CITY OF SAN ANTONIO

Re: Culebra Creek

MDP # 773

MASTER DEVELOPMENT PLAN
 for
 CULEBRA CREEK

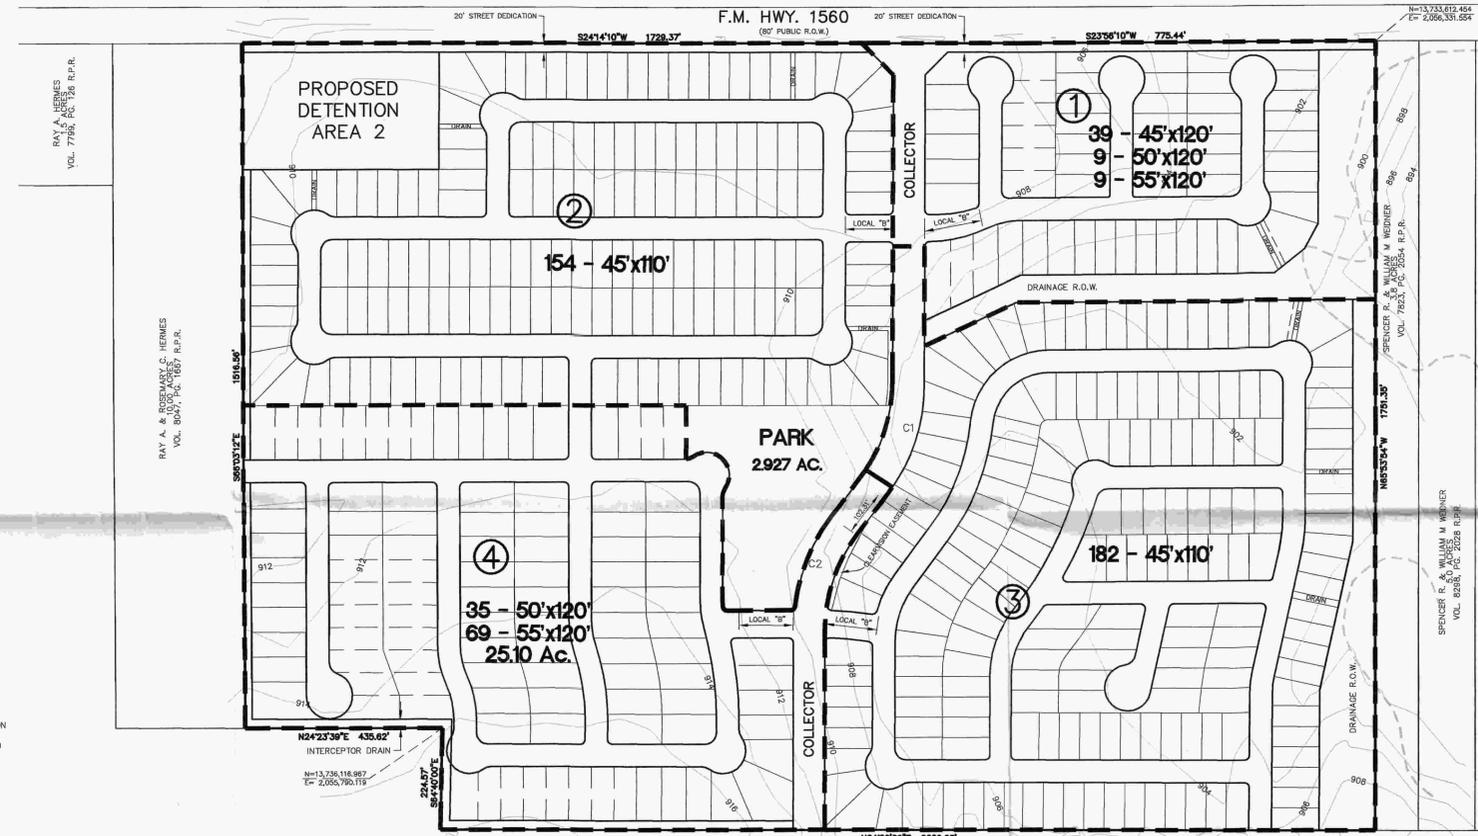
- In consideration of public safety and convenience, excessive grades by reason of topography should be avoided in street layouts and arrangements.

1. It should also be understood that this is a conceptual plan and that all UDC Requirements will be implemented for all plats, within the limits of this MDP. This includes such items as intersection sight distances, street design and pavement requirements, traffic calming, cul-de-sac requirements, right-of-way requirements and widening for a left turn lane and right turn deceleration lane.

2. All Roadways shall conform to Table 506-1: Functional System Description.
- Any access and R.O.W. issues along state facilities will need to be resolved with the Texas Department of Transportation (TXDOT). For information about these requirements you can contact TXDOT at 615-5814.

- This development will need to comply with tree preservation ordinance #85262. For information about these requirements you can contact Building Inspections at 207-7102.

- It will be expected that you will plat all of the property depicted in your Master Development Plan (M.D.P.) to include floodplains, drainage areas and open space.

Culebra Creek is a subdivision of 497 units. Based on Section 35-503 of the UDC, the park dedication requirement for this development is 4.4 acres.

1. Dedication of 2.927-acre park to the Culebra Creek Homeowner's Association. Dedication to be in compliance with requirements set forth in 35-503(f)(2).
2. Trees shall be planted parallel to all perimeter right of ways. Trees are to be a minimum caliper of 3 inches and planted approximately 35 feet on center. Trees may be of the following species: Cedar Elm, Live Oak, Red Oak, Chinquapin Oak, or Monterrey Oak. Developer to guarantee all trees for a period of one year from installation.
3. Park to include at least three of the following improvements: playground, informal play area, trail, parking/access control, park furnishings, or landscaping. Improvements to be submitted with Unit 2 and approved by the Parks Department.
4. Fee in-lieu of dedication in the amount of \$13,846.20. Fee must be paid prior to recordation of the first plat filed under this plan.

1. The floodplain limits on this Master Development Plan (MDP) are estimated and subject to change. Approval of subdivision plats associated with Master development plan will be subject to the review and approval of a Storm Water Management plan in accordance with appendix B, section 35-B119 of the city of San Antonio Unified Development Code (UDC).
2. Detention is proposed.
